From: Kresl, Zachary (FHWA) <zach.kresl@dot.gov>
Sent: Wednesday, March 3, 2021 1:02 PM
To: Smith, Jacob; Maiefski, Melissa; Petracek, Sue; pjinfne@dot.gov
Cc: Barber, Jon; Pitts, Luke
Subject: RE: For Your Review: Plan Revision R-1 Reevaluation, 21209, Murray - Plattsmouth

Subj: Project No. NH-75-2(128), C.N. 21209, Murray – Plattsmouth
Plan Revision R-1

Revised Sheets:	A2
Deleted Sheet:	B6
Added Sheets:	B6A, N13, N14

THIS SET OF PLANS IS
DRAFT PLAN REVISION 1

TYPICAL CROSS SECTIONS

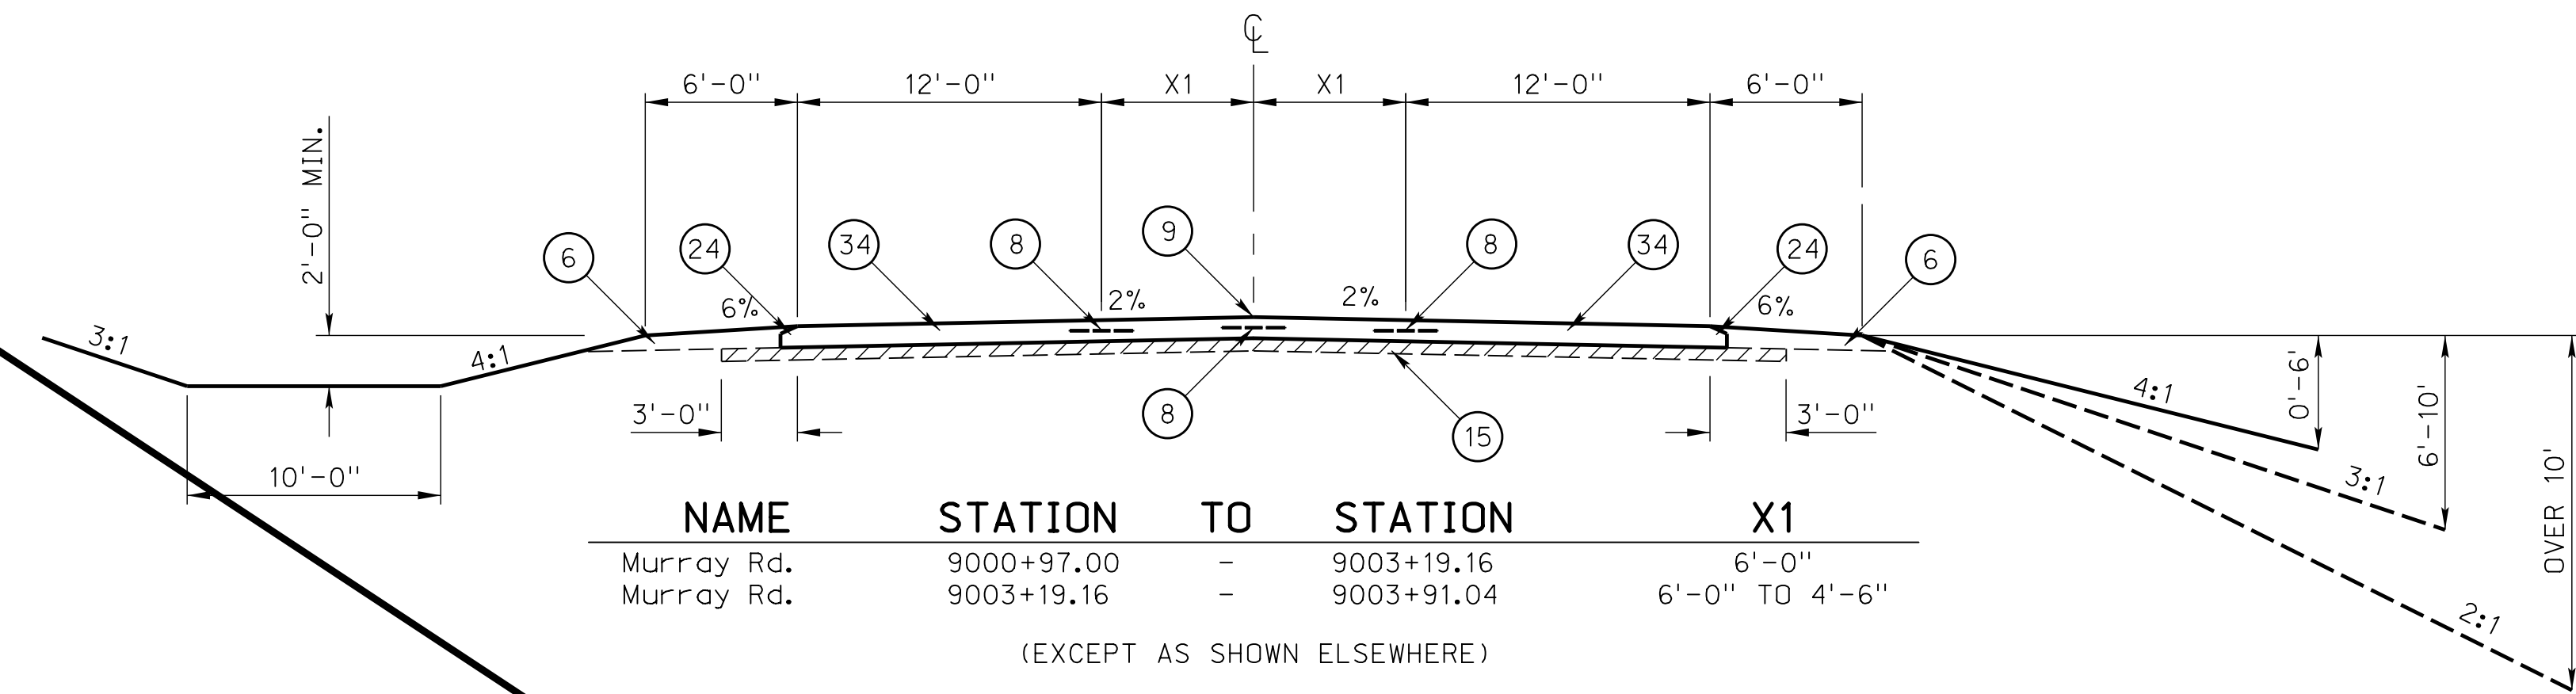
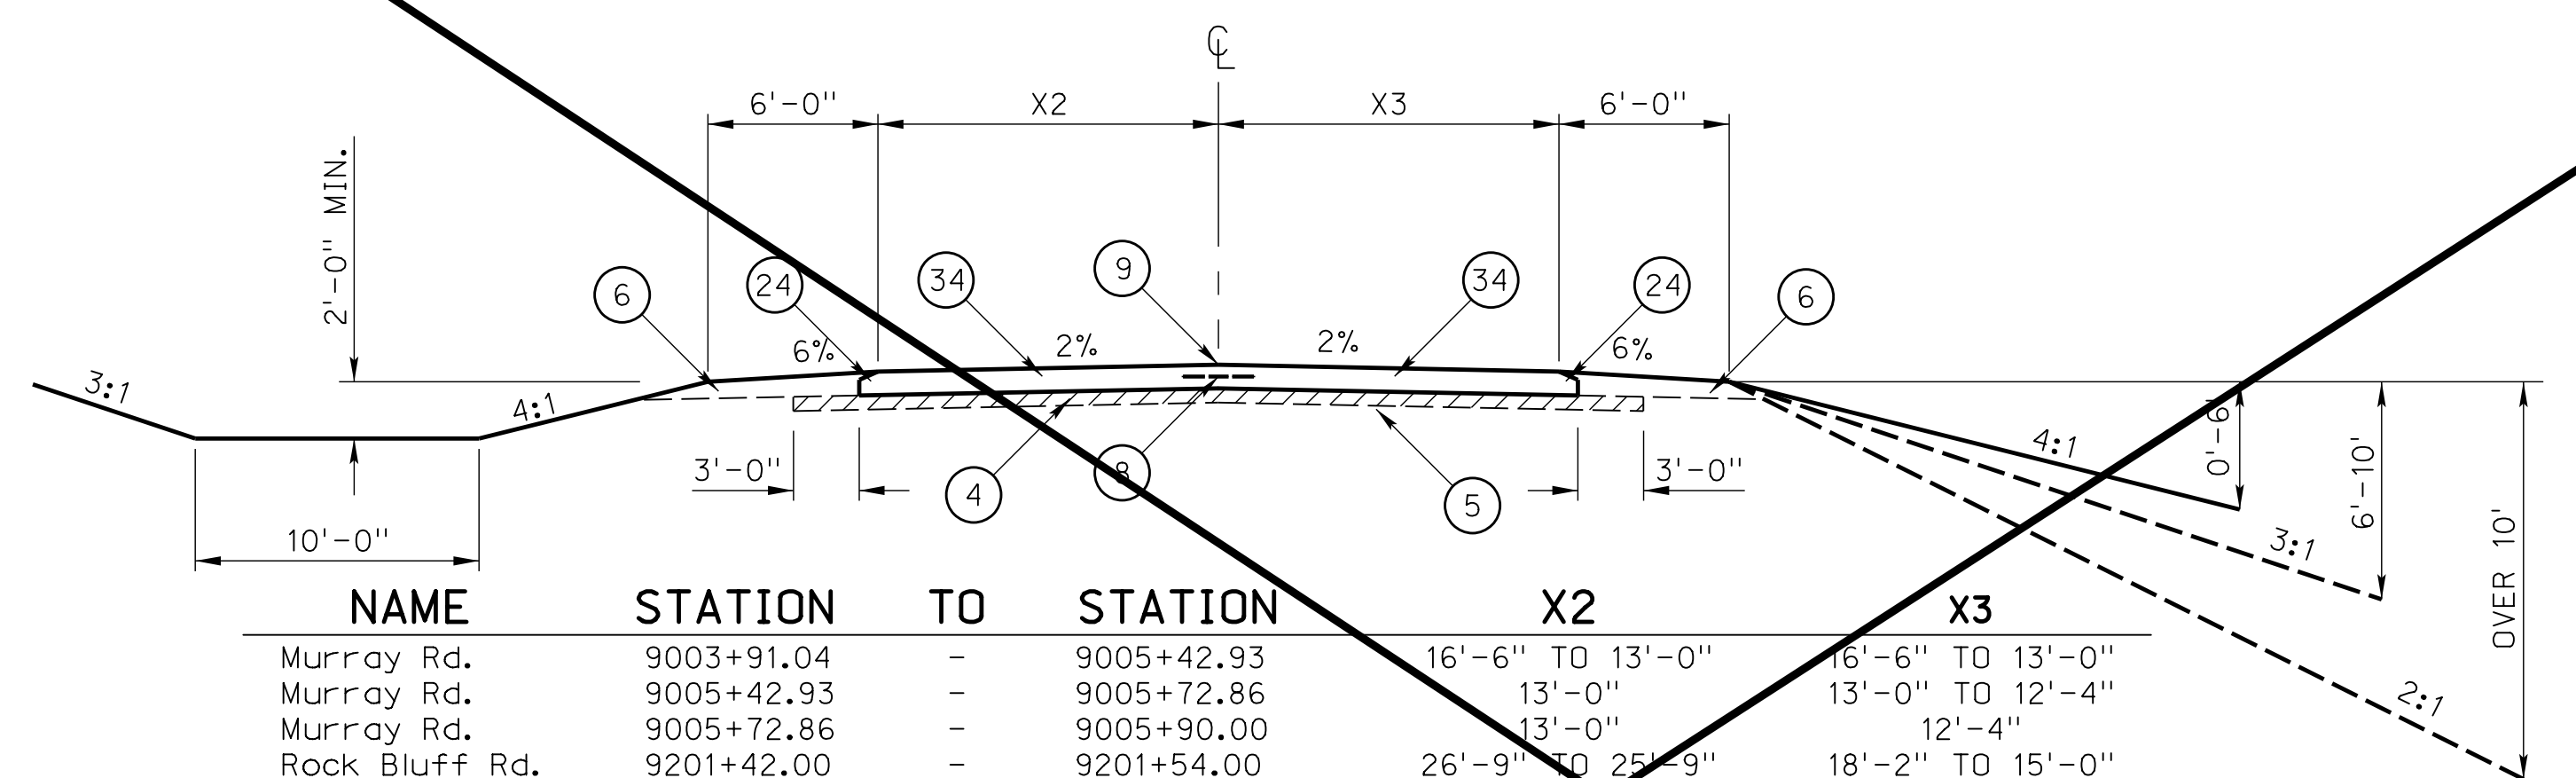
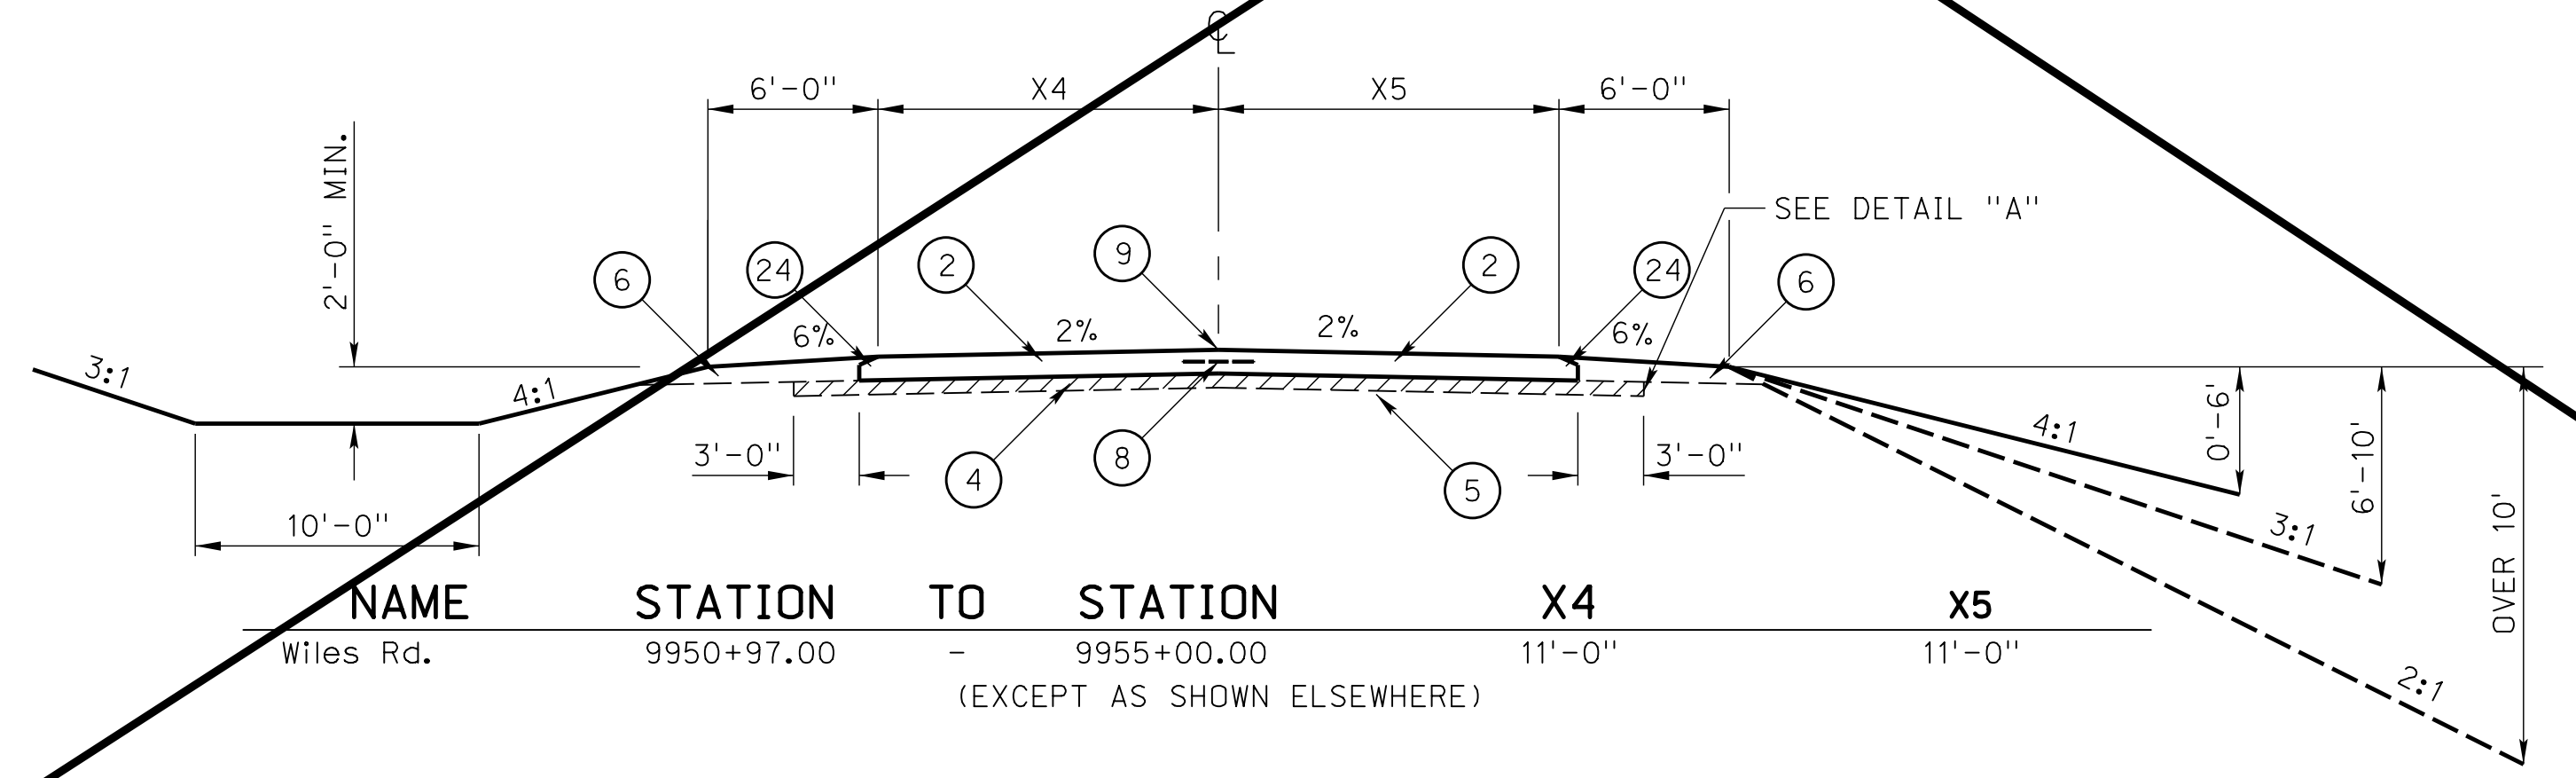
- Sheet B6 was deleted and sheet B6A was added to accommodate various typical changes:
 - The line titled “Rock Bluff Rd.” for station range “9201+42.00 – 9201+54.00” is void and has been removed per Addendum 1.

- In response to a contractor question in the letting process and confirmed by Roadway Design, the third typical on sheet B6, the number 2 bubble for 10” Concrete Pavement, has been changed to a number 1 for 10” Doweled Concrete Pavement.

- To coordinate with M&R pavement quantities that were provided in the letting plans, Foundation Course was added to Murray Rd. as well as Stabilized Subgrade, Type Lime. A new typical was created for Church Rd. since its base structure is only Subgrade Preparation and no Foundation Course. The line titled “Horning Rd.” for station range “9801+17.74 – 9801+49.00” is void and has been removed. Roadway Design, M&R, and Construction are in agreement with these changes.
